10/765,634

Robert W. Helt

Office Action Summary	Application No. 10/765,634	Applicant(s) HELT ET AL.	
	Examiner Gene L. Bankhead	Art Unit 3744

DETAILED ACTION

Figure 12a (Dushane)

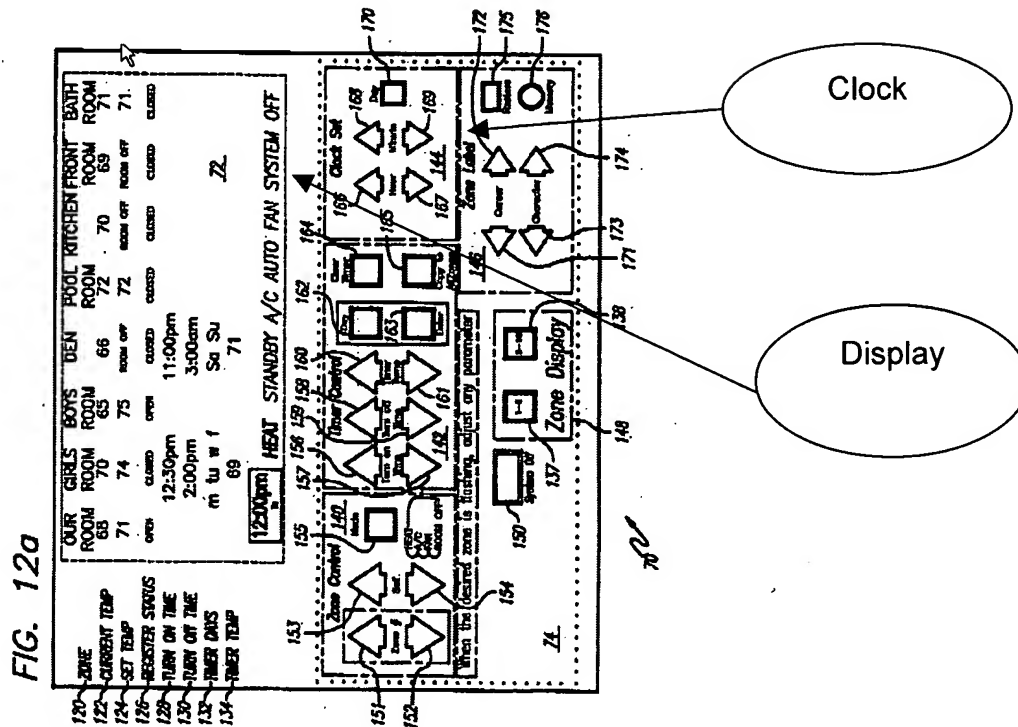
Regarding claims 3 and 5 Dushane discloses a thermostat with a master controller 70 corresponding to the claimed "control here" switch actuator (Figure 12a) that affects the control of the air conditioning unit to control the temperature in accordance with the temperature set point (column 11 lines 25-35). Dushane further discloses a clock 144 and a visual display of time (Figure 12a). Dushane further teaches switch actuators capable of setting a time displayed by one of said thermostats to effect a change in the time displayed by each of the thermostats (column 9 lines 58-68).

Regarding claim 7 Dushane discloses multiple thermostats with at least one including a time display, a Daylight Savings Time icon, and a Daylight Savings Time switch actuator capable of adjusting the time during Daylight Savings time periods (Figure 12a and column 11 lines 33-35).

With regard to claim 22 Dushane discloses thermostats including a clock, a time display and a clock setting switch actuator (Figure 12 a) and capable of setting the clock at one of the thermostats to display the time at all the thermostats.

With Regard to claim 28, Dushane discloses a thermostat with a master controller 70 corresponding the "Control Here" switch actuator (Figure 12a) that affects the control of the air conditioning unit to control the temperature in accordance with the temperature set point (column 11 lines 25-35).
